Background Tank 93 Information

Tank 93 - Overview

Tank 93 Recommendations

Tank 93 CP System Monitoring

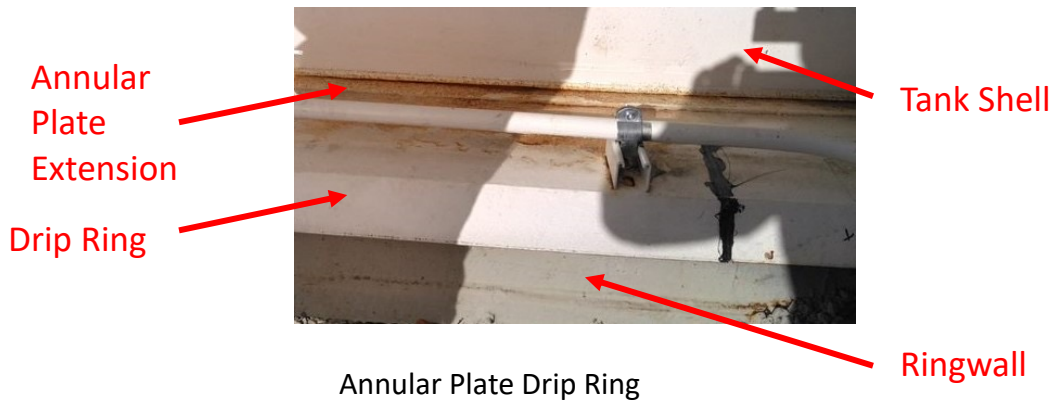
- AMPP (formerly NACE) standards call out two criteria for cathodic protection (CP).
 - A polarized potential of -850 mV (accounting for IR drop), or
 - 100 mV of polarization.
- The AMPP standard (NACE SP-0193) requires that in order to use the 100 mV criteria, the operator should measure the formation or decay of polarization.
 - APSC's internal written procedures align with the AMPP standard with regard to monitoring the formation or decay of polarization.

Tank 93 Roof Support Column Inspection & Repair Issues

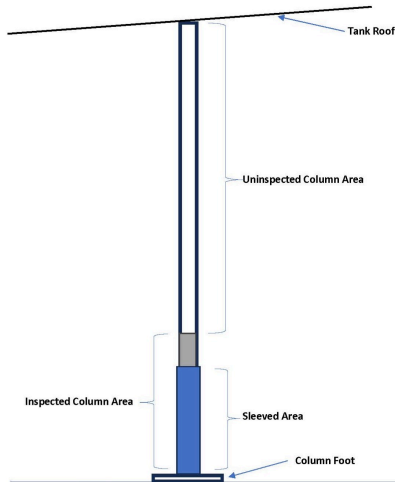
- Inspection of the roof support columns was expanded from spot readings at the bottom to comprehensive inspection of the bottom 20-feet of the columns.
- The APSC engineering summary report indicated that lower portion of each roof support column was inspected.
- Sleeves were installed on the bottom 15-feet of the outer columns.
- Internal anodes were installed in the columns

Tank 93 Roof Support Column Inspection Issues

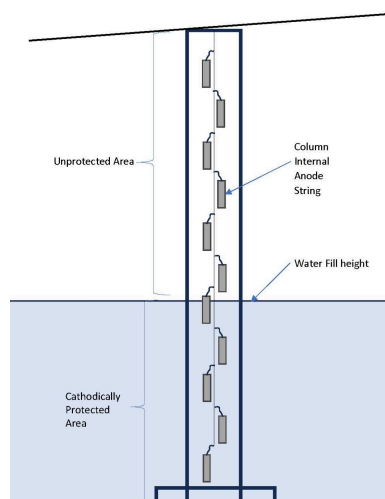
- The Engineering Summary report indicated that corrosion identified on the columns was most severe at the lower portion of the columns.
 - No data was provided to support that finding.
- Values for the column minimum remaining effective structural thickness (T_{EST}) and minimum required remaining effective structural thickness ($60\% T_{NOM}$) of the outer columns were provided but no calculations were provided for ascertaining those values.
